ADDENDUM
(February 2014)

2012 NDS Changes

Figure A1. Bolted connection cases A, B, and C.

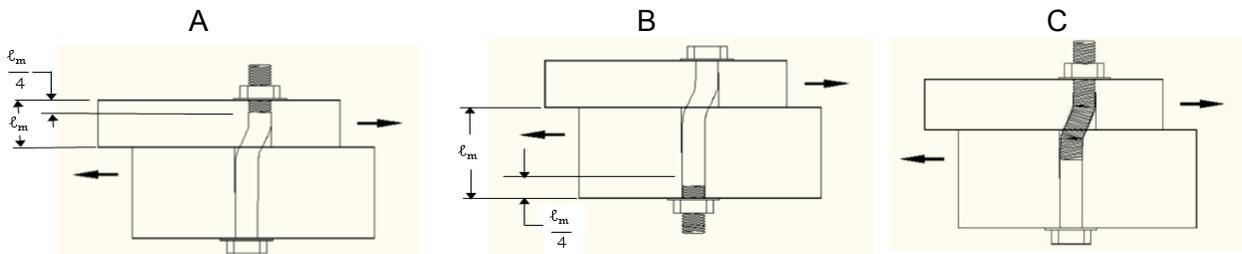
1) Add to section on “Dowel-type Fasteners” as follows:

“Section 11.3.6 Dowel Diameter was renumbered to Section 11.3.7 and revised to remove a requirement that permitted use of fastener diameter, D , in lieu of fastener root diameter, D_r , in calculation of lateral connection values for bolts that conform to requirements of ANSI/ASME Standard B18.2.1. The change provides greater consistency with NDS provisions for threaded fasteners by establishing D_r as the default diameter for use in calculation of lateral connection reference design values. Provisions of 11.3.7.2 allow for use of D where the threaded portion of the fastener is adequately far away from the shear plane (e.g. threads do not exceed $\frac{1}{4}$ of the full bearing length of the member holding the threads) or where a more detailed analysis shows that that moment resistance of the threaded portion due to its location in the connection does not control the yield limit state value. Reference lateral design values for bolted connections in Tables 11A through 11I continue to be based on diameter D . In accordance with Section 11.3.7.2, these tabulated design values are applicable for cases where the threaded portion is away from the shear plane as shown in Figure A1 cases A and B. For a bolted connection in accordance with Figure A1 case C, where threads are in the shear plane, tabulated lateral connection values based on D_r are applicable unless a more detailed analysis of the effect of the threaded portion on the controlling connection yield limit state value is conducted.”

Section	Description
Chapter 11	9) Provisions allowing lateral connection values of bolt connections to be based on fastener diameter D , where bolts meet requirements of ANSI/ASME Standard B18.2.1, were removed. Applicability of D for calculation of lateral design values is consistent with treatment of other dowel-type fasteners (Section 11.3.7.2).
